ZONING CONDITIONS FOR THE MERRITT RESERVE

CONSTRUCTION DRAWINGS FOR MERRITT RESERVE

PROJECT NUMBER = CID-25-XX

PROJECT NUMBER = PSP-24-07

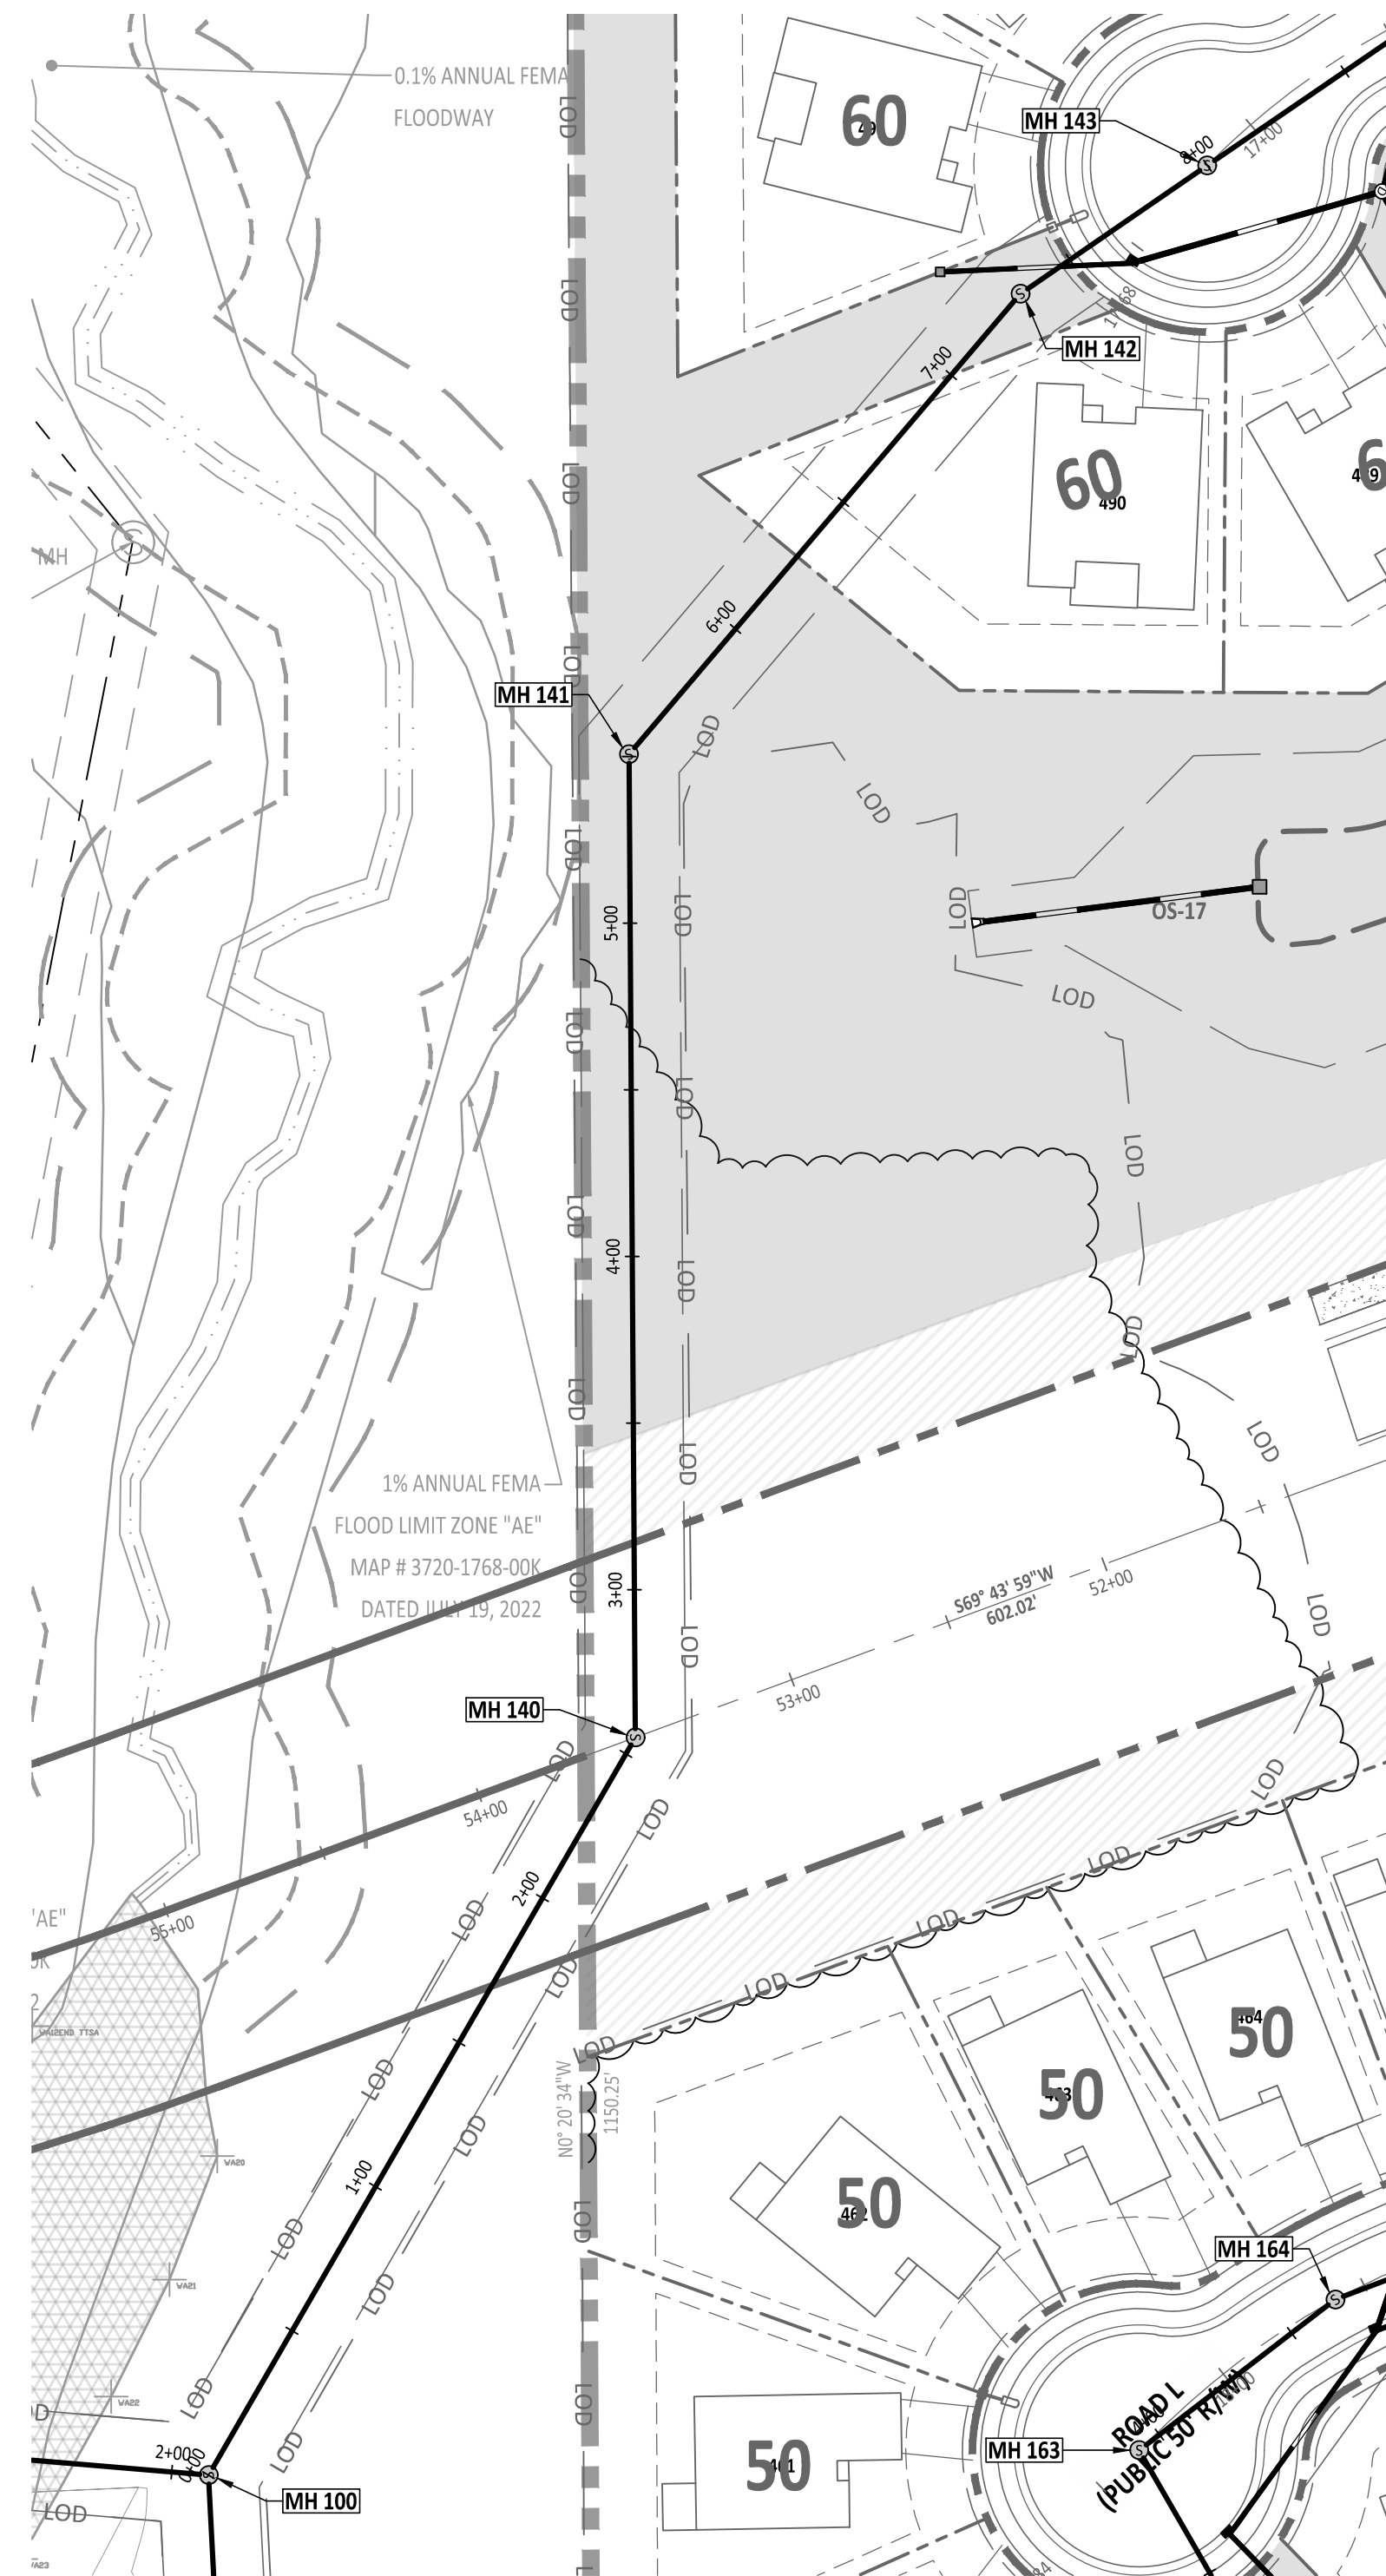
Must be DIP material at this depth. In fact, this main should also be installed within a casing at this depth for future maintenance.

Please call out all MH dia. If more than 12' installation depth, MHs must be 5' dia. If greater than 20' MHs must be 6' dia.

Try to get this installation less than 20' if possible, if absolutely not possible, DIP is required.

THIS WILL BE CORRECTED SEPARATELY. WE ARE CURRENTLY GOING THROUGH POSSIBLE LAYOUT CHANGES TO REDUCE COST OF THE PROJECT. THE MATERIAL AND MANHOLE SIZES WILL BE UPDATED WHEN SEWER DESIGN IS FINALIZED.

THIS WILL BE CORRECTED SEPARATELY. WE ARE CURRENTLY GOING THROUGH POSSIBLE LAYOUT CHANGES TO REDUCE COST OF THE PROJECT. THE MATERIAL AND MANHOLE SIZES WILL BE UPDATED WHEN SEWER DESIGN IS FINALIZED.

THIS WILL BE CORRECTED SEPARATELY. WE ARE CURRENTLY GOING THROUGH POSSIBLE LAYOUT CHANGES TO REDUCE COST OF THE PROJECT. THE MATERIAL AND MANHOLE SIZES WILL BE UPDATED WHEN SEWER DESIGN IS FINALIZED.

THIS WILL BE CORRECTED SEPARATELY. WE ARE CURRENTLY GOING THROUGH POSSIBLE LAYOUT CHANGES TO REDUCE COST OF THE PROJECT. THE MATERIAL AND MANHOLE SIZES WILL BE UPDATED WHEN SEWER DESIGN IS FINALIZED.
